Yarralumla Residents Association Submission 28 August 2020

Development Application: 202036734 - Section 64 Block 19 Yarralumla 39 Bentham Street and 33 Hutchins Street

DA 202036734 – Proposed Development Elevation

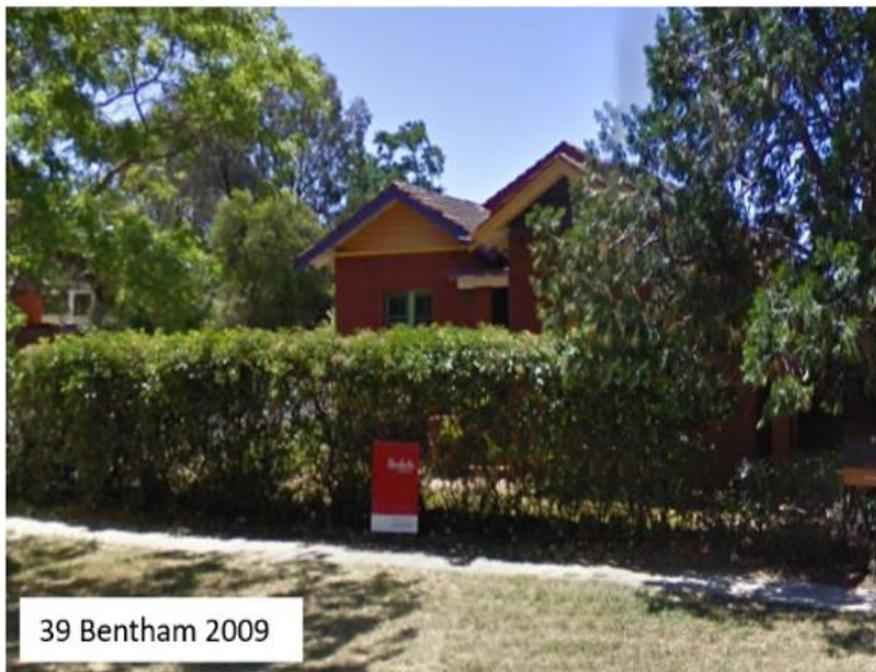
DA Elevation diagram and the DA Statement of Heritage Effects demonstrate that the sole “reference” to the original cottages is some recycled red bricks surrounding two windows and a low red brick pillars at the street entrance to the proposed dwellings. In all other aspects the architecture of the proposed development is totally modern, square, flat roof, rendered brick, minimal planting areas, and does not reference any other heritage features.

Therefore the DA does not meet the requirements stated by the ACT Heritage Council DA Task Force that it was prepared to consider and agree in principal *“to a proposal to demolish what little remains of the original cottages and to construct a group of terrace houses in a high quality landscape setting which referenced elements of the original cottages, particularly red brickwork, and was commensurate with other recent quality medium density development in Yarralumla.”*

The DA is totally dismissive of any attempt to reference or redress other heritage aspects thus effectively ALL heritage is lost.

The DA Heritage Statement states that any attempt to reconstruct the facades of the former cottages “would likely result in historic a pastiche which is not an appropriate solution”. This is not correct.

The Developer should therefore be required to ensure that the new development addresses the Heritage Values of the site to the maximum extent. It is not sufficient just to incorporate a few recycled red bricks. This should not become a Green fields site with no heritage constraints or make good heritage requirements.
